October 14, 2022

To: U.S. Army Corps of Engineers

Re: Requesting a REJECTION of Enbridge's Line 5 Tunnel Project Proposal

Mississippi Headwaters Crossing Clearwater County Muddy Upwelling adjacent to Mississippi bleeding into the waterway

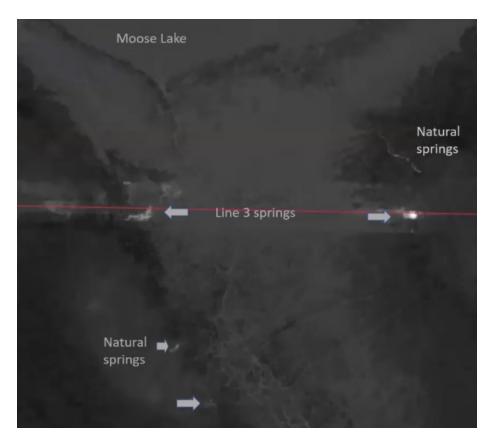
Mississippi Headwaters Citizen Monitoring 3-1-2022 Orange Water from upwelling Spring near the corridor Dark Water from upwelling Frac-out area
